PLANNING COMMISSION REPORT
Regular Agenda -Public Hearing Item

**ITEM NO. 13 SMARTCODE COMMUNITY INFILL PLAN REDEVELOPMENT PROJECRT
1401 W. 23RD STREET (SLD)**

ITEM NO. 13A COMMUNITY INFILL PLAN; SMARTCODE (SLD)

Consider a request to establish a community infill plan associated with a SmartCode application at 1401 W. 23rd St & 1300 W. 24th St. Submitted by Opus Development Company LLC, for George B. Leinmiller and Marlene J. Leinmiller, property owners of record.

All Parking shall be located in the Third Lot Layer (21-500.5.4 (f))

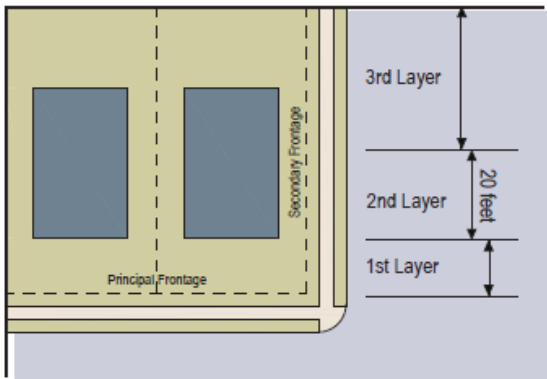
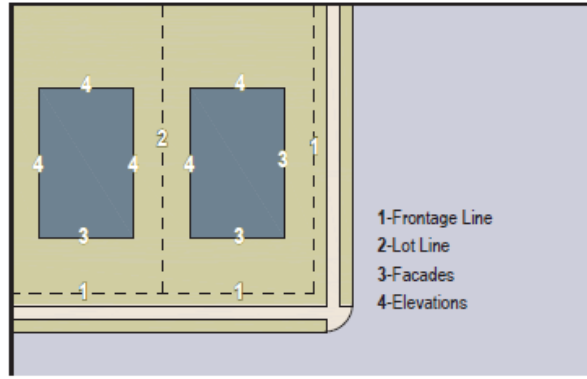
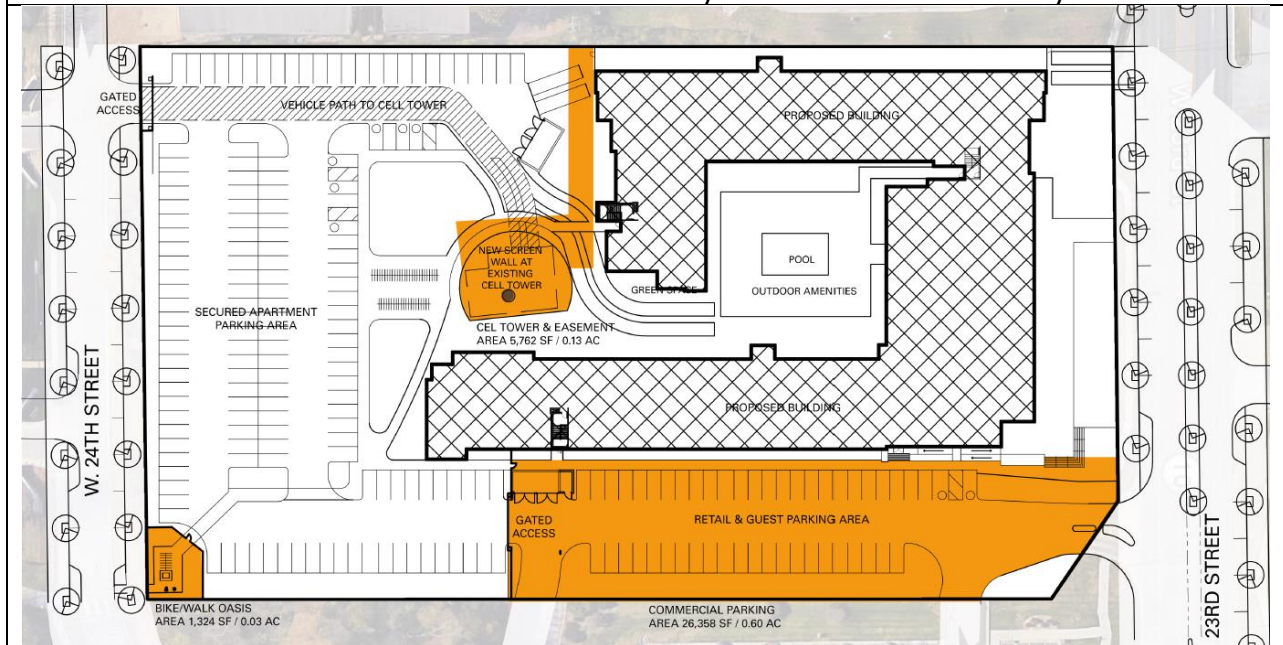
General parking standards are set out in Section 21-500.5.4. The SmartCode defines how lots shall be used, and in what portions of the lot certain uses can be located. This project includes off-street parking located along the east side of the building near W. 23rd Street. This parking accommodates commercial uses that front W. 23rd Street.

The site is not designed with a rear alley or on-street parking. The nearest parking for the commercial use would be located in the 1st and 2nd layer of the lot for accessibility considerations.

Minimum Base Density: 30% "other" functions (Table 14, Summary B, Minimum Base Density)

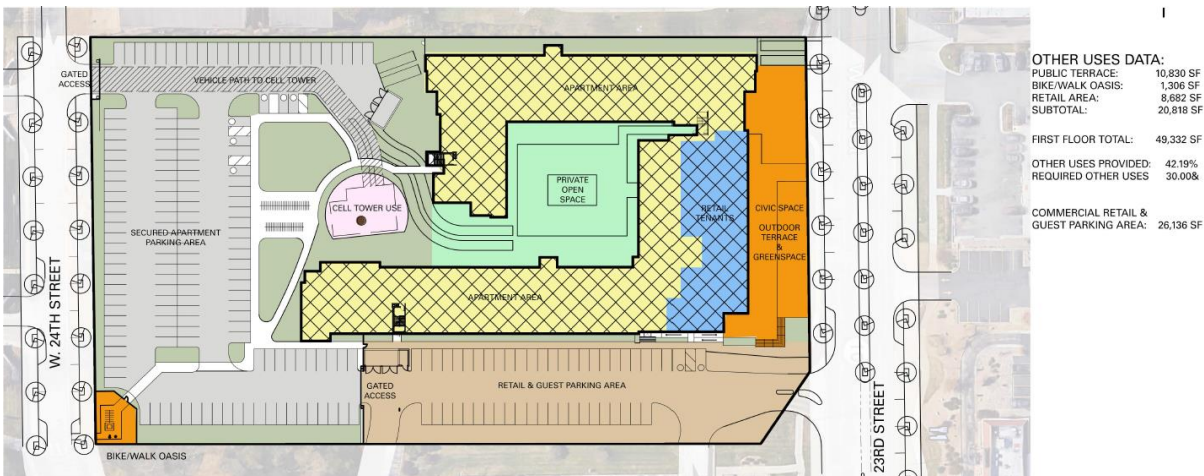
The proposed plan deviates from meeting the required "other" functions within the project. The applicant measured the use of "other" functions based on the total area of the first floor (49,332 square feet).

The SmartCode does not define how this criterion shall be evaluated. The unit of measure influences the outcome of the mix of uses. Density is defined based on land area. The purpose of the SmartCode is to implement mixed-use developments. Staff reviewed the requirement for "other" functions based on the lot area (4.4390 acres), not the footprint of the first floor of the building.

Staff finds that the total land area attributed to "other" functions is only 23%. A larger project encompassing multiple lots would be better able to meet the mix requirement than a single lot.

Deviation 3:
Maximum Lot Width, 150 feet (Table 14, Summary F, Lot Occupation)

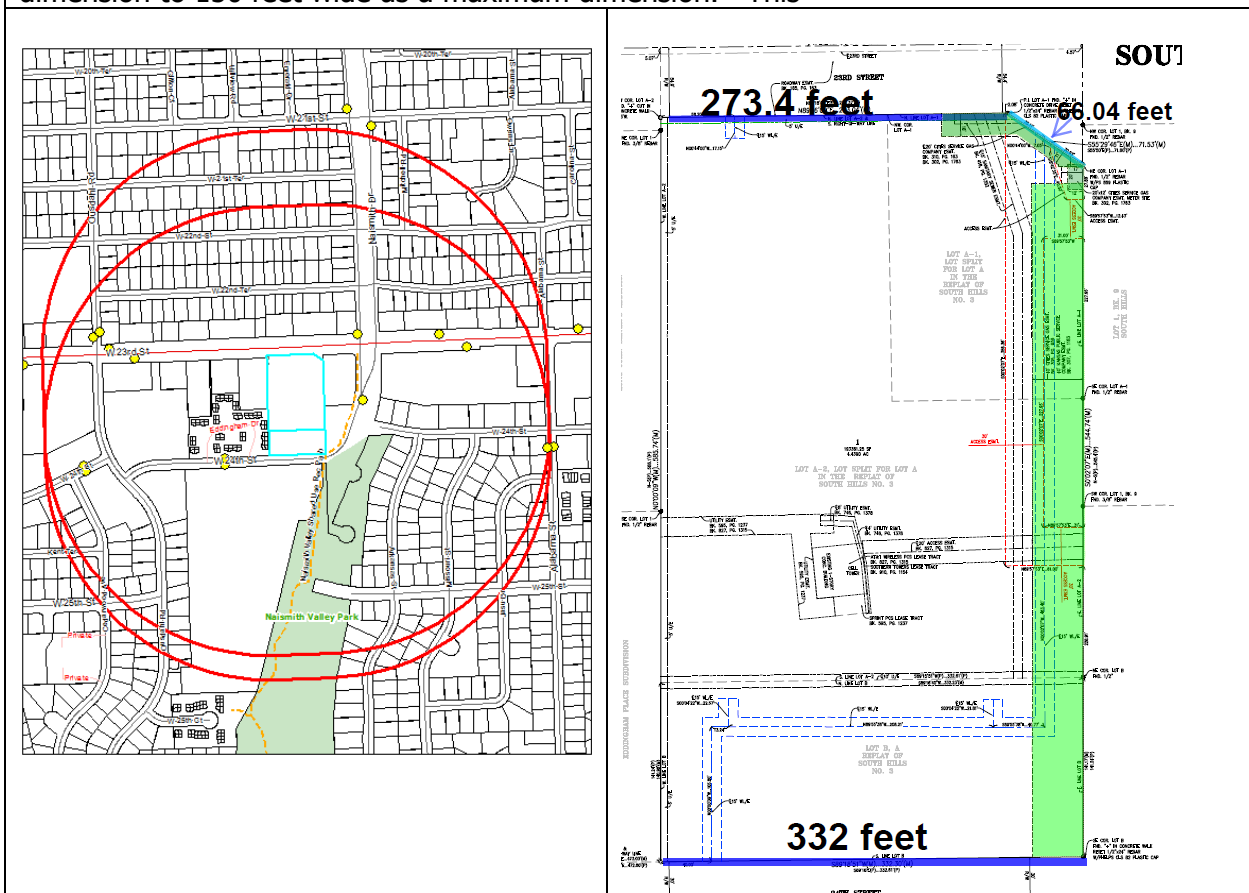
Conventional development may include larger buildings and “big box retail” structures that are not conducive to pedestrian-scale walkable neighborhoods. The lot size and configuration is discussed in the body of the minor subdivision staff report. Development is based on pedestrian sheds that are typically one-quarter mile in length with a high degree of amenities that support pedestrian, scale and use, including lot and block sizes. For this reason, lot and block sizes are prescribed in the SmartCode.

This project includes only one lot within a developed urban block bounded by W. 23rd Street on the north, Naismith Drive on the east, W. 24th Street on the south and Ousdahl Road on the west. Within the subdivision context, lots would range from 25 feet wide as a minimum dimension to 150 feet wide as a maximum dimension. This

The above graphics shown the location of within the context of the block, and the details of the lot, including the exclusive 40 foot gas line easement located along the eastern property line.
